Brookhaven National Laboratory
Plant Engineering - E&CS Division
Engineering Change Notice Form

PROJECT: CCWF II **JOB No.** 11705

ECN Title: Electrical Site Plan and Conduit Details **ECN No.** 33

Affected Documents: ES-101, EP-301, CE-03, CE-05, EP-302, ES-402

ELECTRICAL SITE PLAN

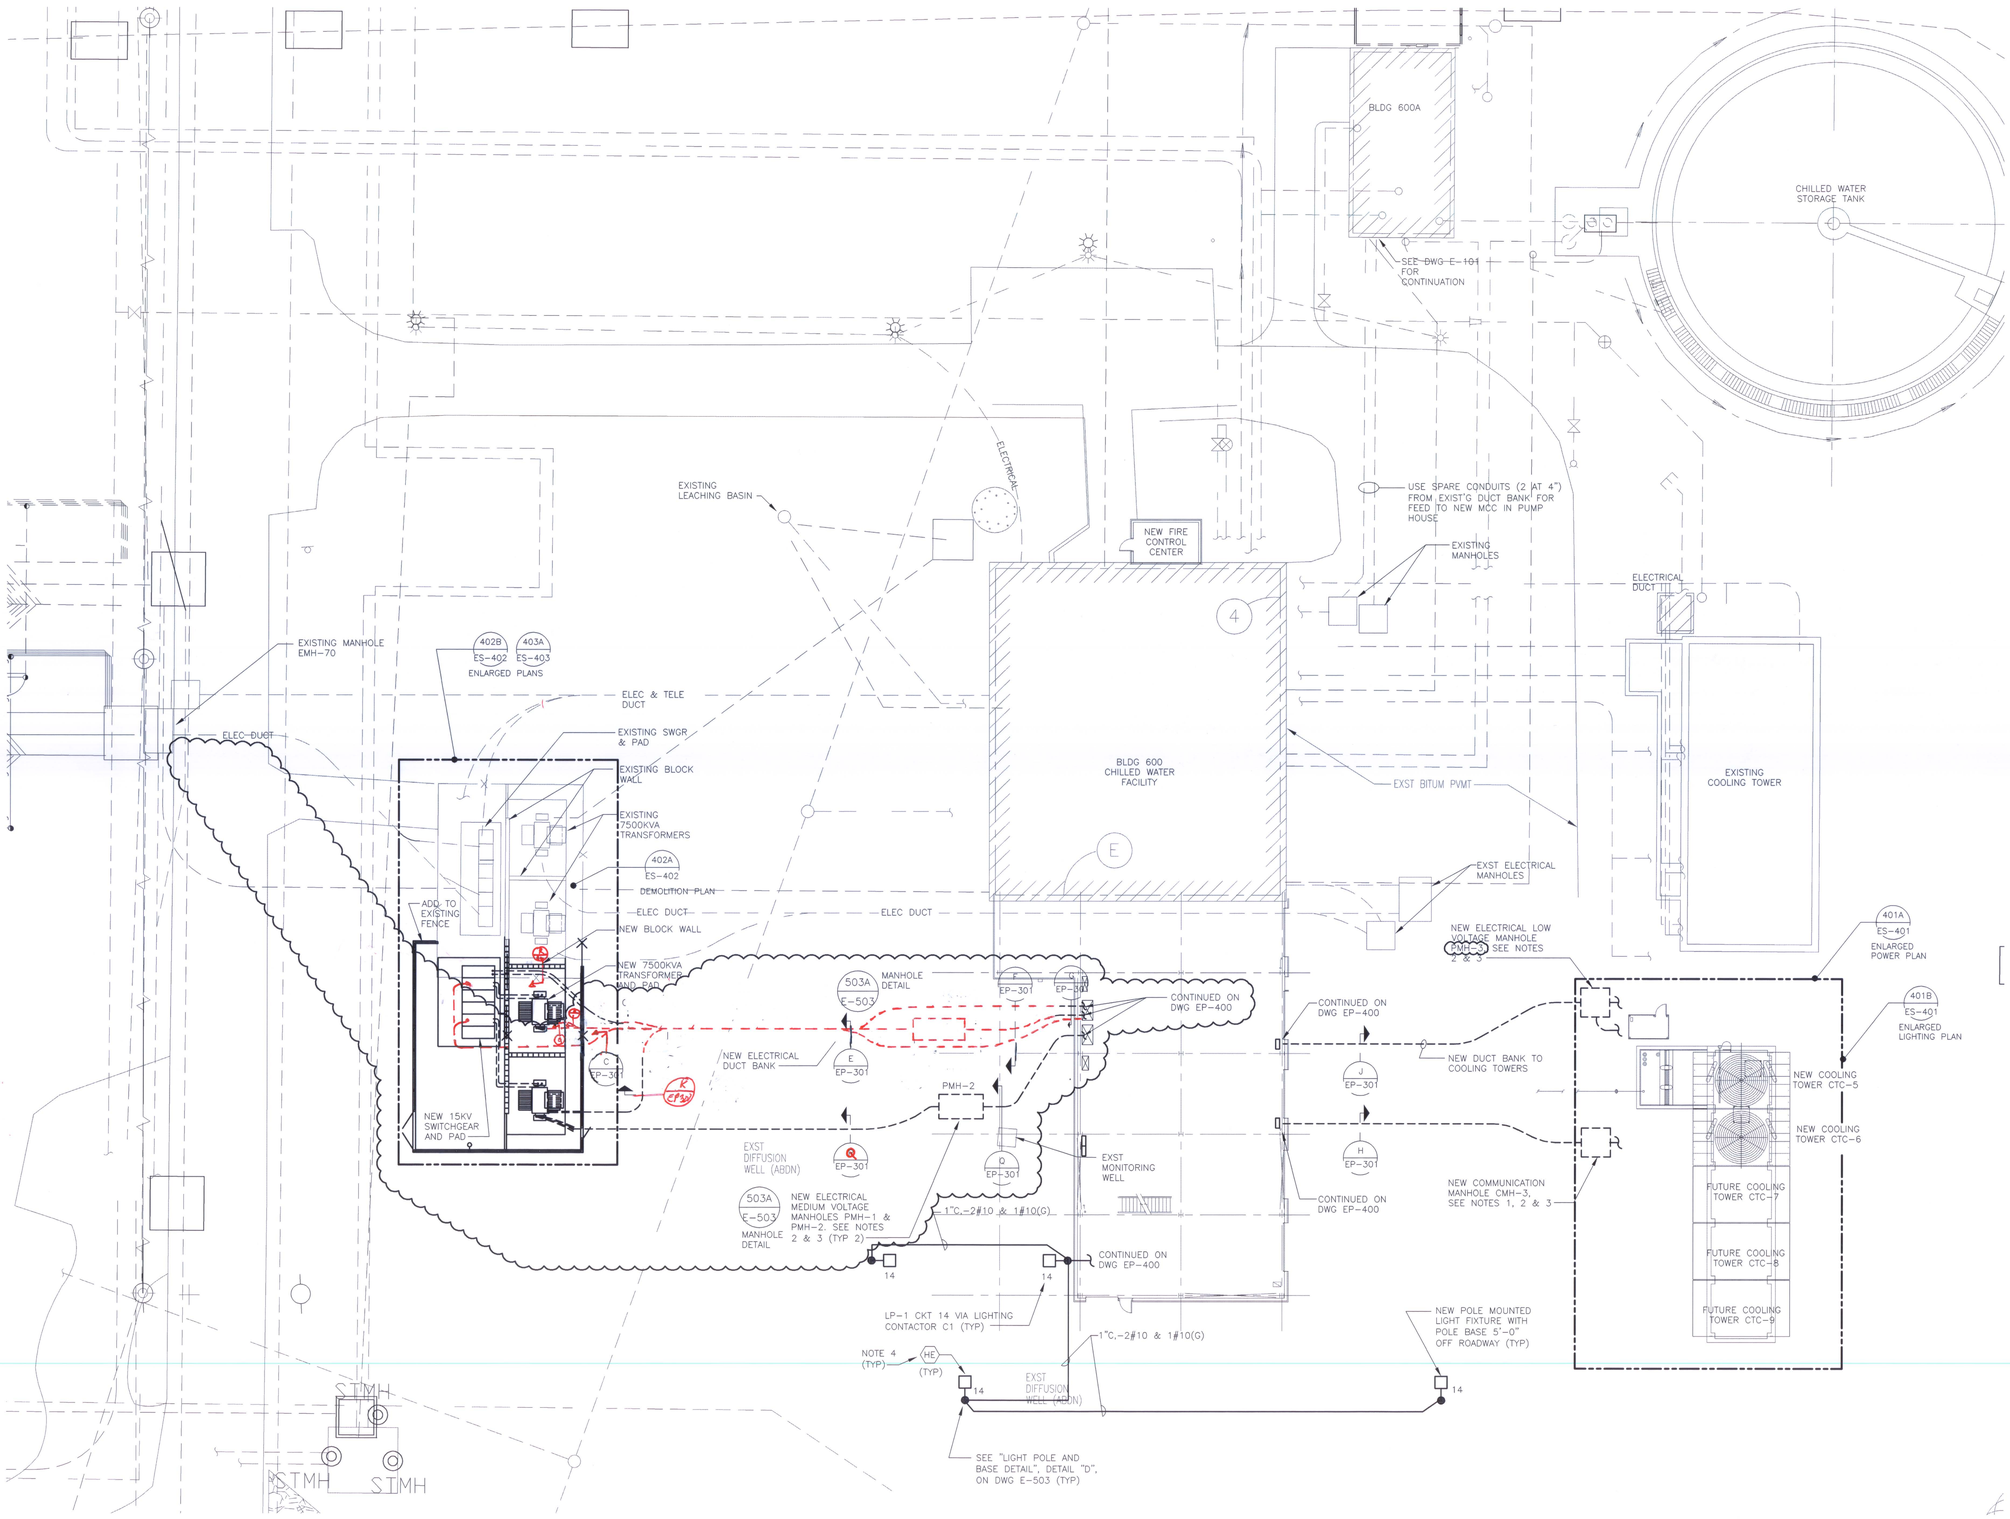
Requested Change (Attach sketch if applicable): Re-designed the electric duct banks and their routing from substation 600-B to bldg 600 to segregate 4160V, 120V and control meter wiring.

2 communications manholes are not required

Resolution: See the attached marked up drawings for new layout and details.

JOB TITLE	CENTRAL CHILLED WATER FACILITY PHASE II
DWG. TITLE	ELECTRICAL SECTIONS
ILR,GPP,LNI, HEM	
DATE	
ACCT. NO.	
SHEET OF	
SCALE	AS NOTED
DWN. BY	EA
REV'D BY	RB
JOB NO.	11705
DWG. NO.	EP-301
ESHQ RISK LEVEL	
APP'D. BY	R BARTOY
BLDG. NO.	600
PATH:

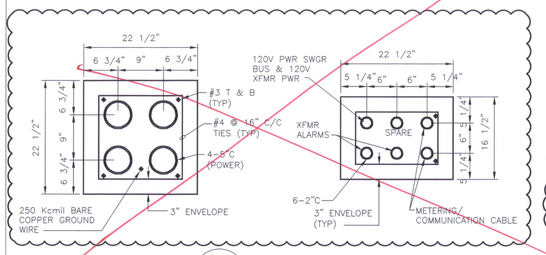
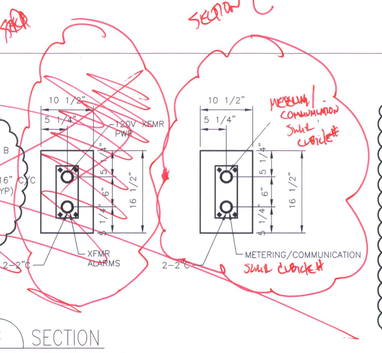
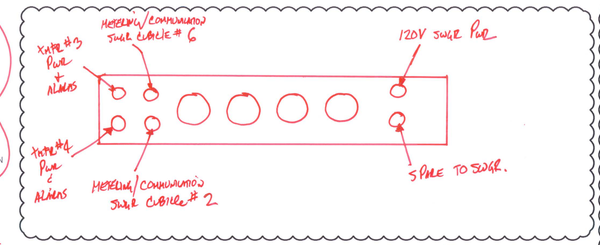
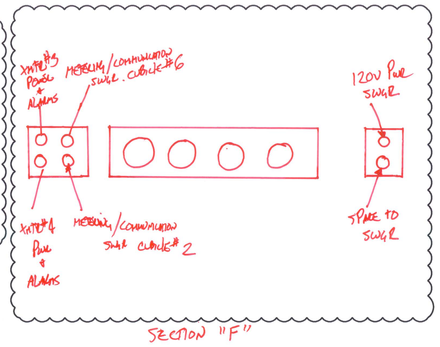
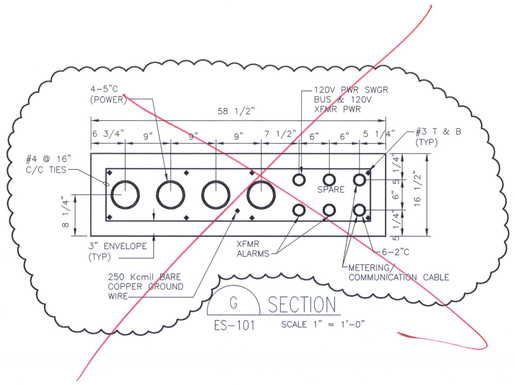
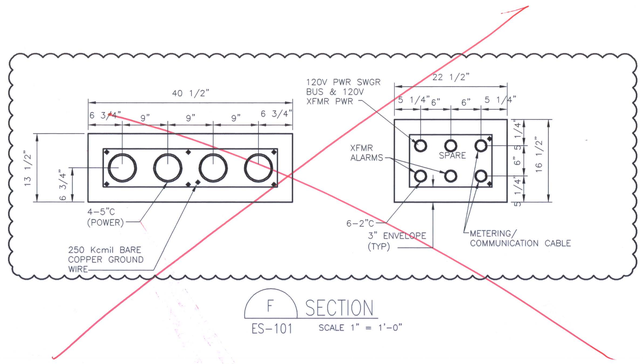
Reinforcing bars are not required for these duct banks.
